Project:	SE Polk CSD Junior High Lighting Replacement	Project Number:	25-174	Date:	March 20, 2026
----------	--	-----------------	--------	-------	----------------

Note { This addendum has been issued to modify and/or interpret the bidding documents, including the drawings and specifications. Unless otherwise instructed, the information contained on the addendum shall take precedence over anything contrary on the original bidding documents and shall be hereinafter considered as a part of the bidding documents.

SHEET NAME:
LIGHTING DEMOLITION PLAN - AREA D

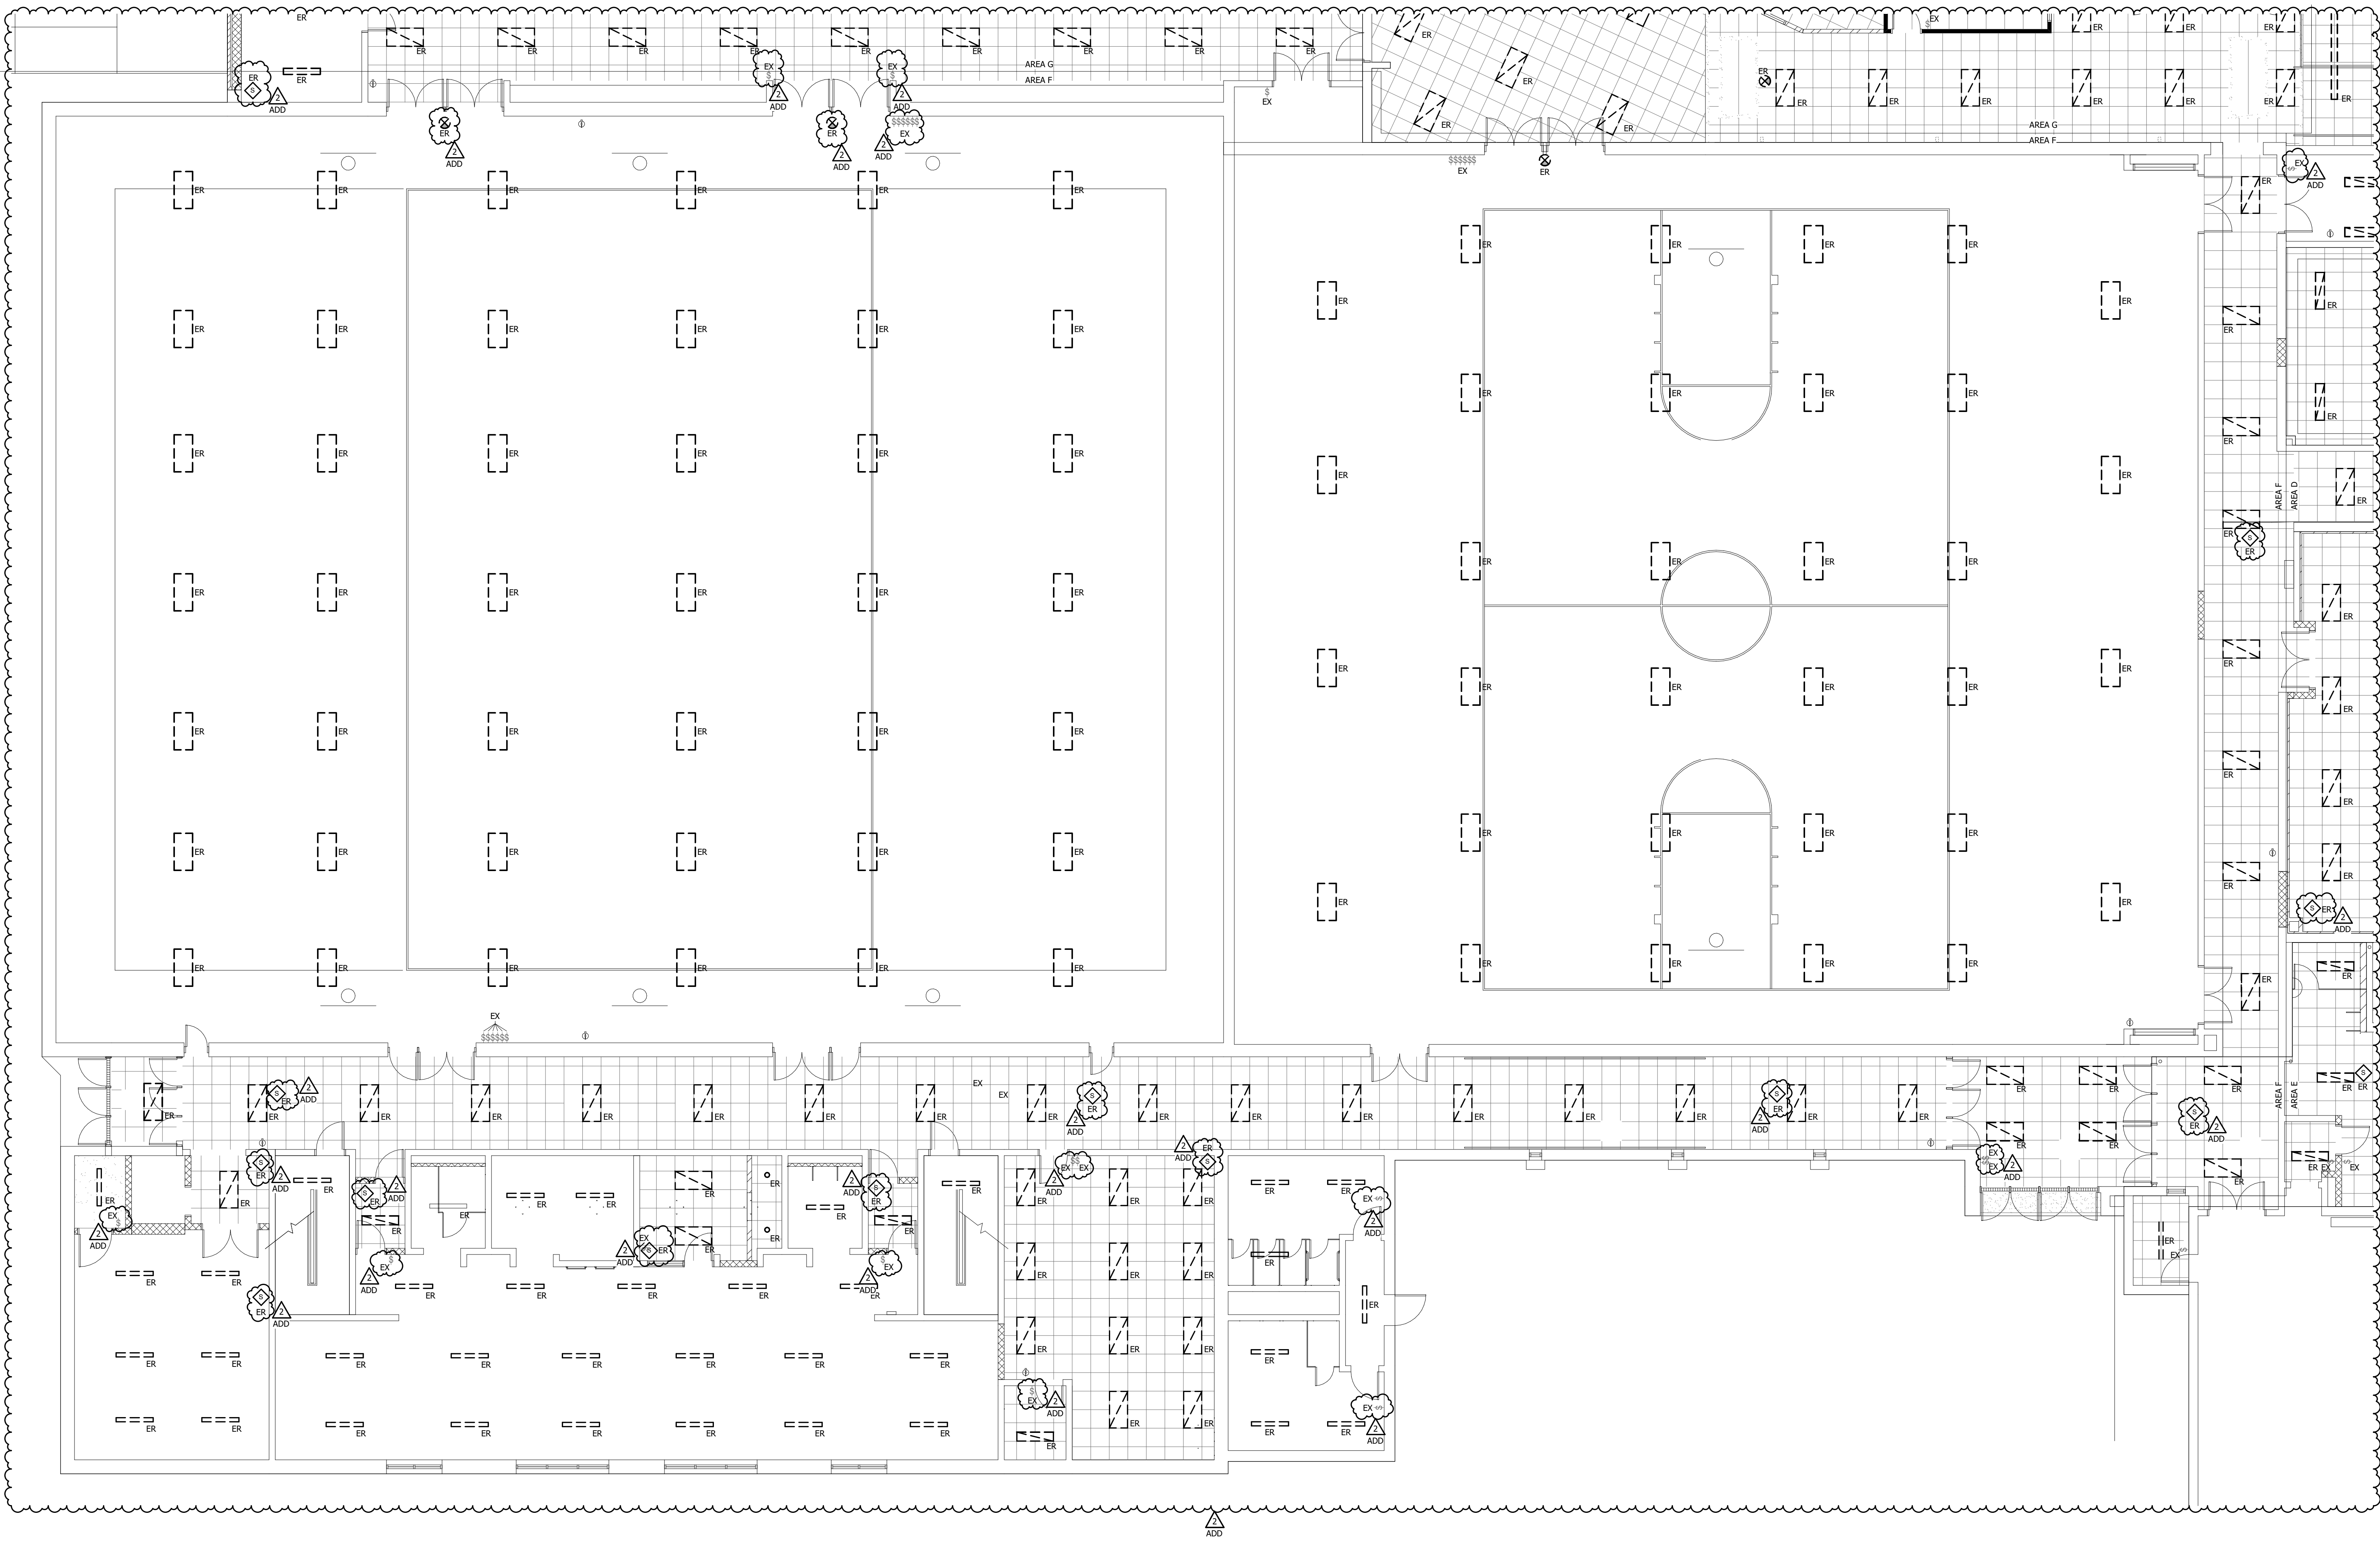
1. **CLARIFY** existing light switches to remain. See drawings for approximate locations.
2. **ADD** existing occupancy/vacancy sensors to be removed and replaced. See drawings for approximate locations.
3. **ADD** existing exit signs to be removed and replaced. See drawings for approximate locations.
4. **REVISE** general note H per attached drawing.
5. **ADD** general note I per attached drawing.

SHEET NAME:
LIGHTING DEMOLITION
PLAN - LEVEL 2 - AREA A

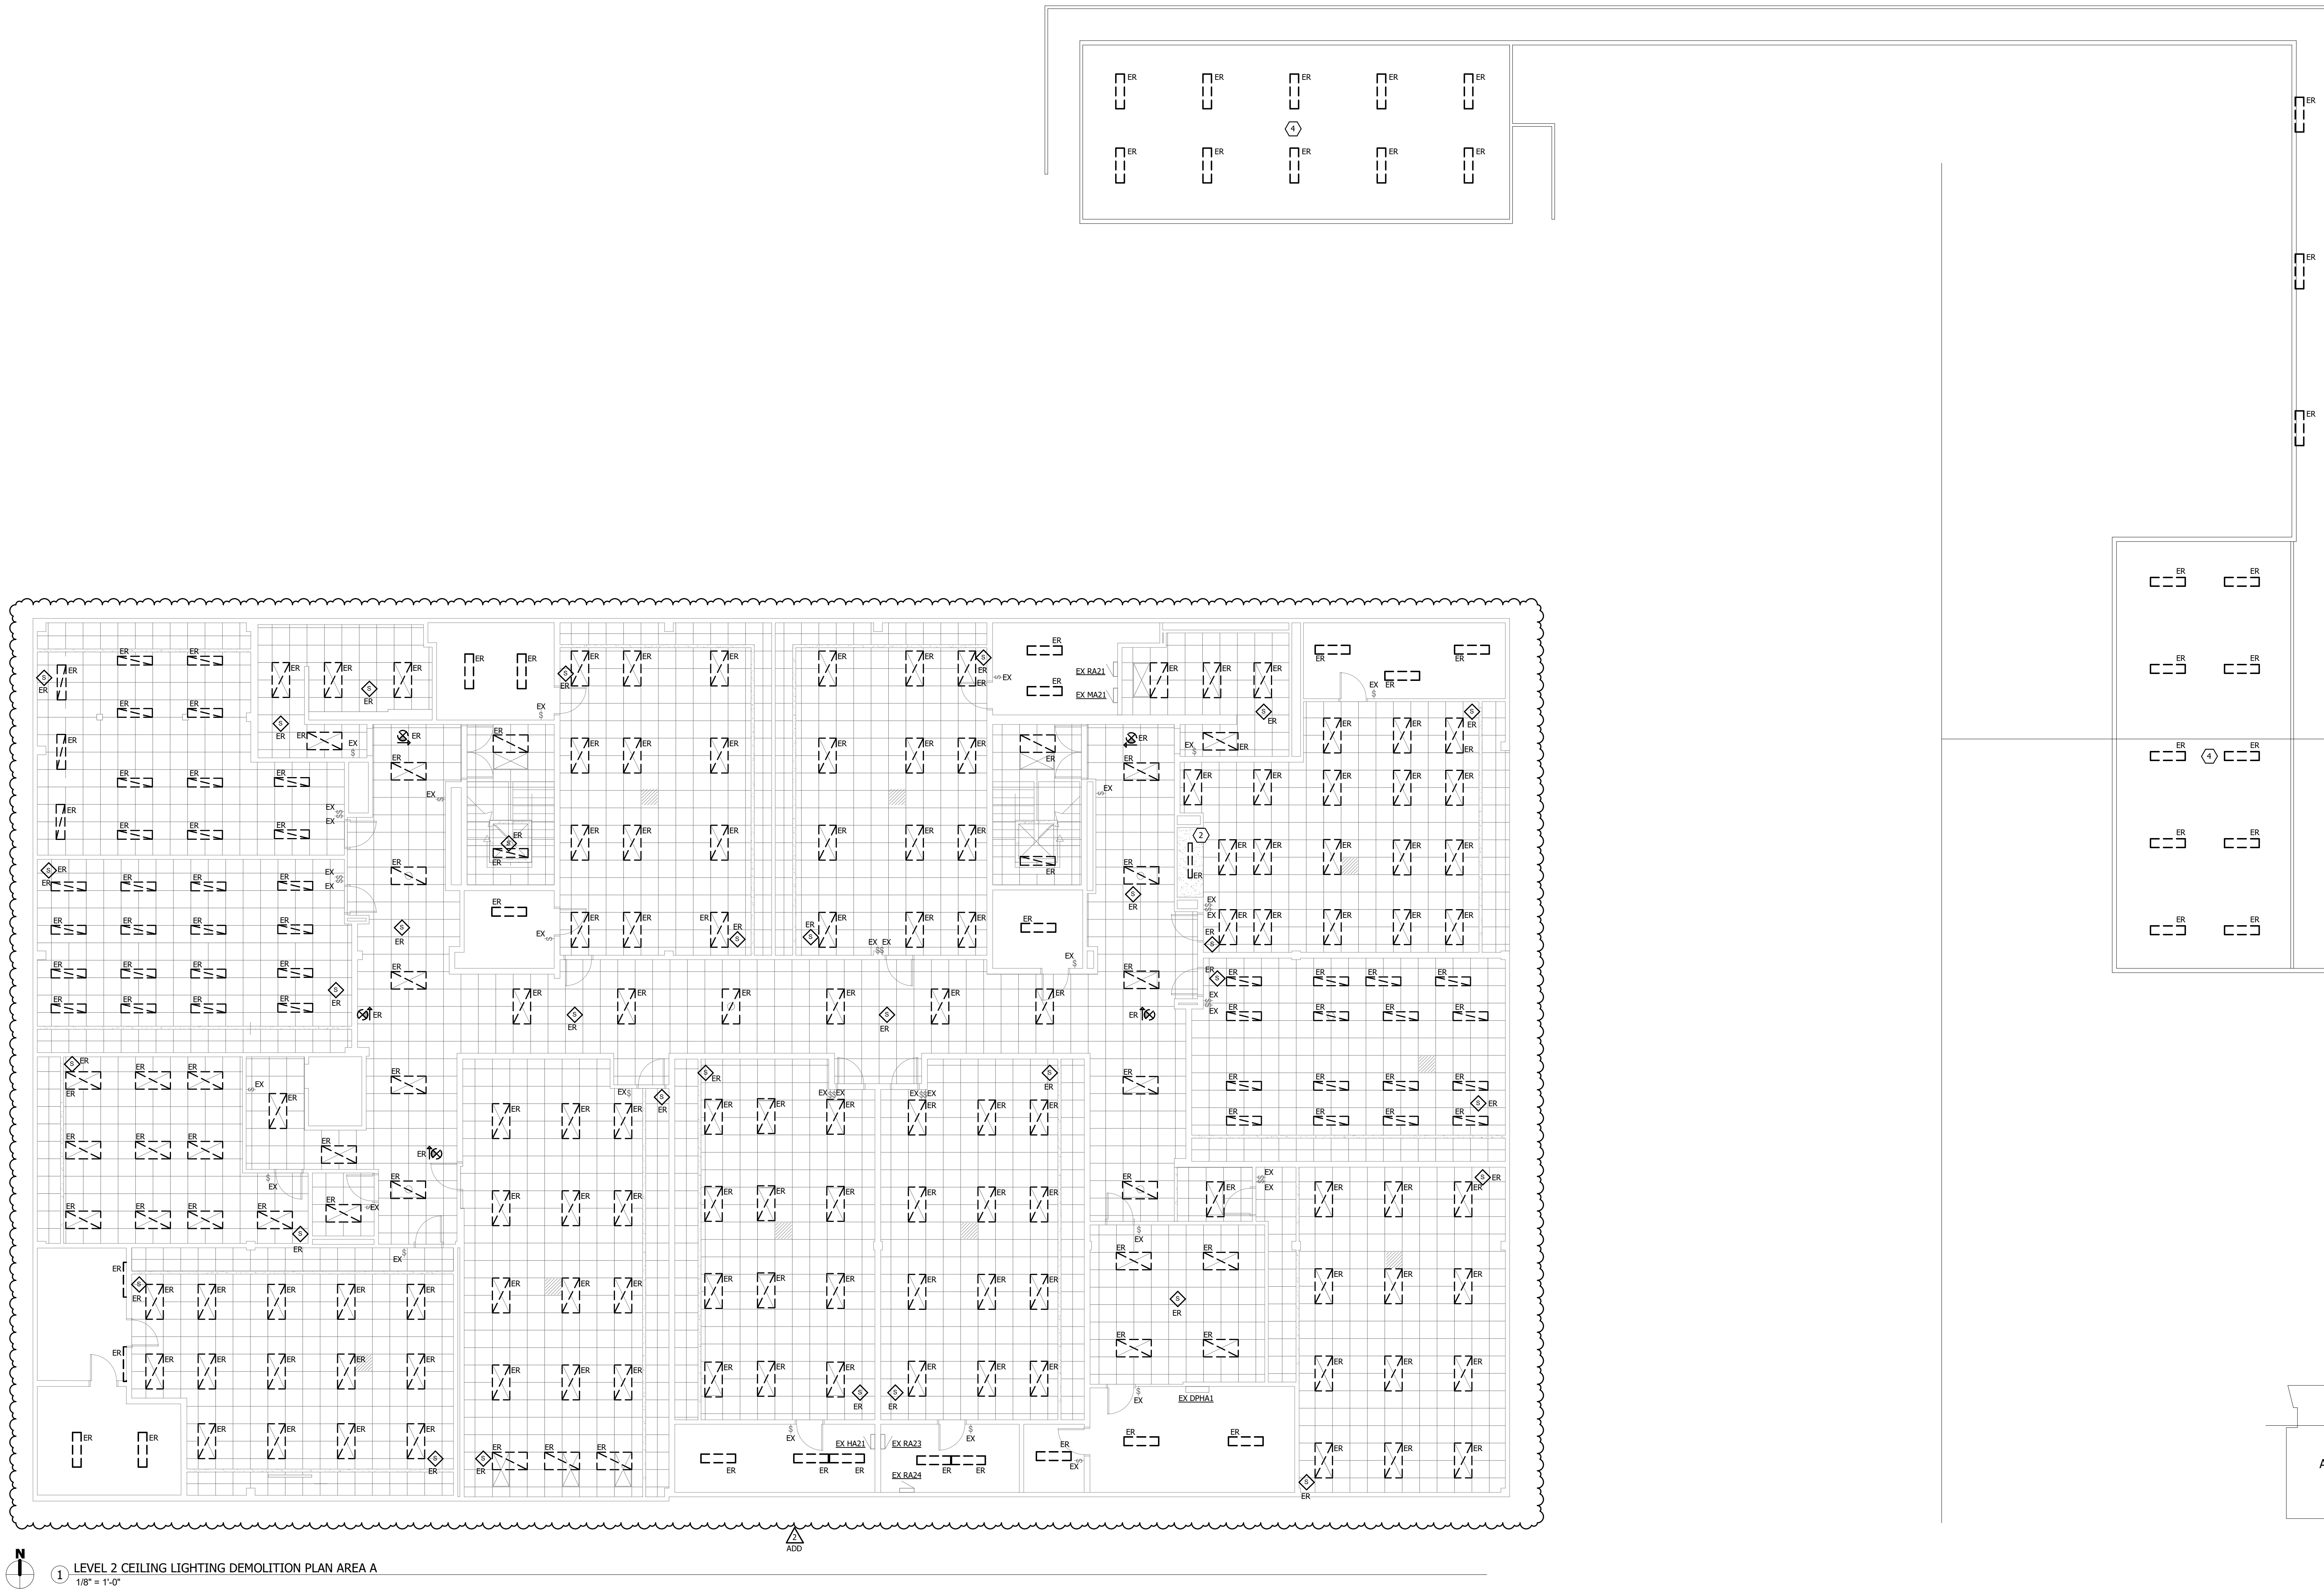
1. **CLARIFY** existing light switches to remain. See drawings for approximate locations.
2. **ADD** existing occupancy/vacancy sensors to be removed and replaced. See drawings for approximate locations.
3. **ADD** existing exit signs to be removed and replaced. See drawings for approximate locations.
4. **ADD** (3) additional fixtures to be replaced in mezzanine link corridor above auditorium stage.
5. **REVISE** general note H per attached drawing.
6. **ADD** general note I per attached drawing.

1 LEVEL 1 LIGHTING CEILING PLAN AREA A - ALTERNATE
1/8" = 1'-0"

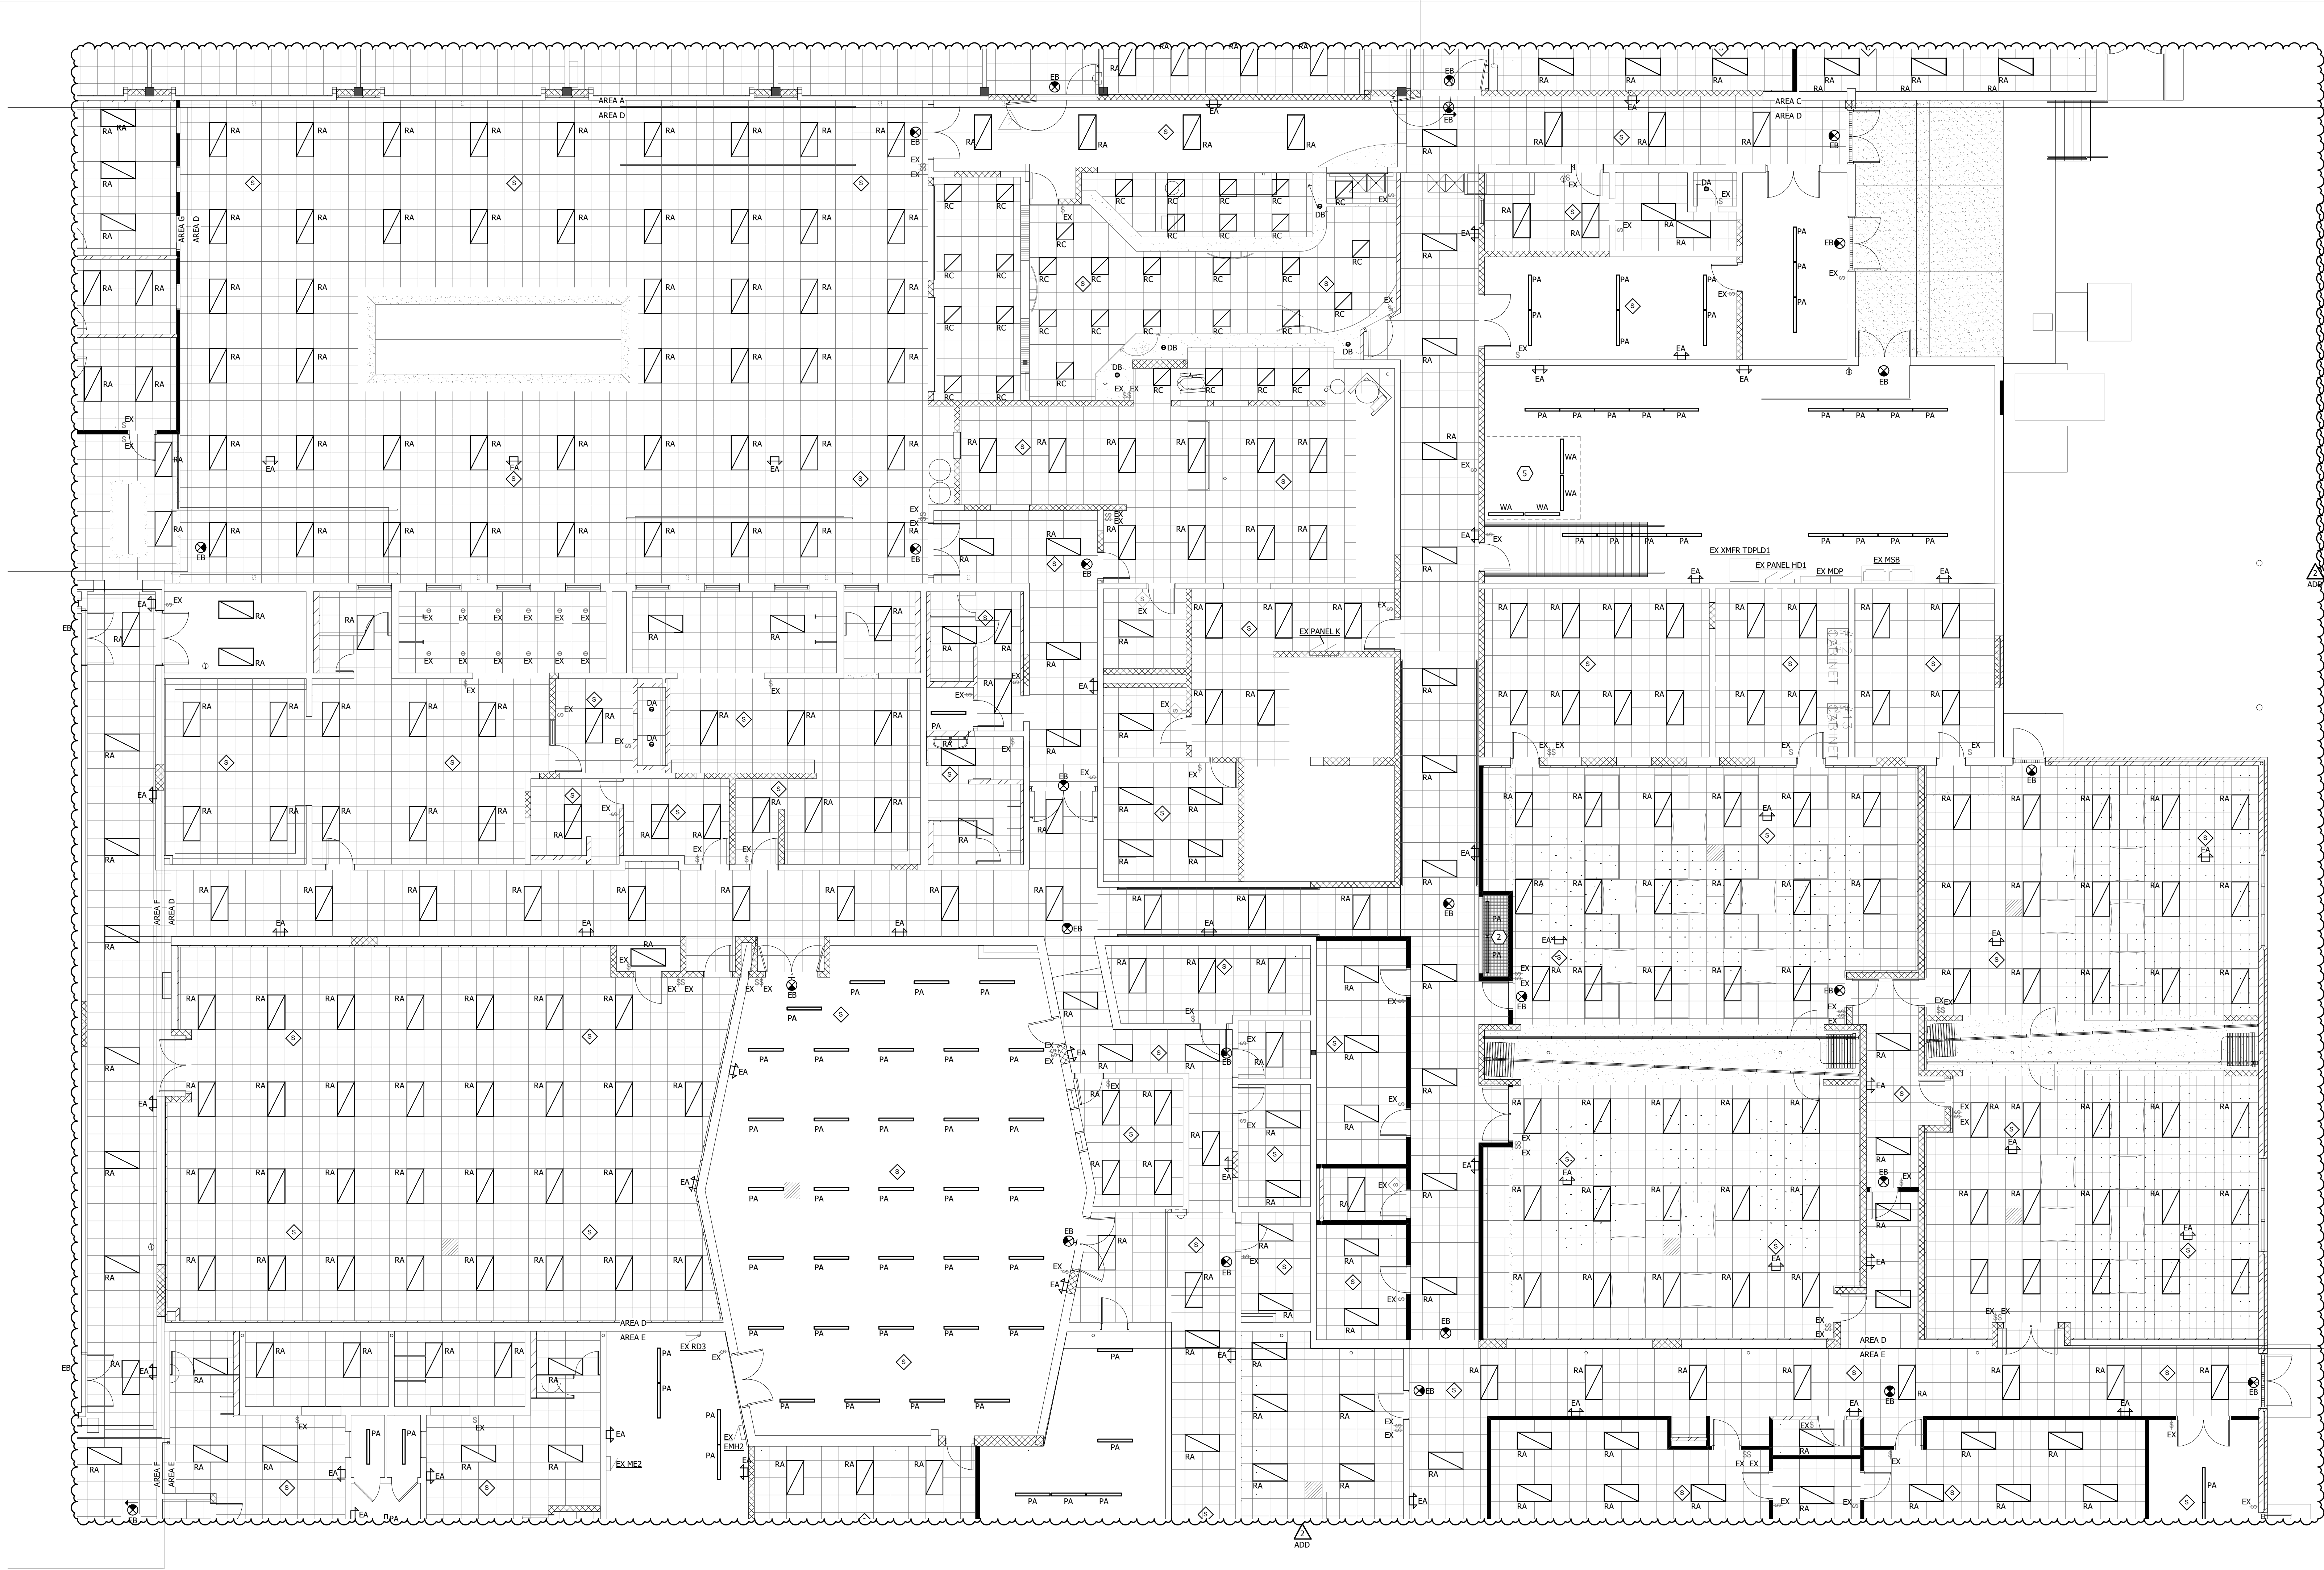
1. **ADD** sheet showing alternate bid lighting layouts in open locker areas and media center. See drawings for layouts.
2. **ADD** referenced note 9 per attached drawing.
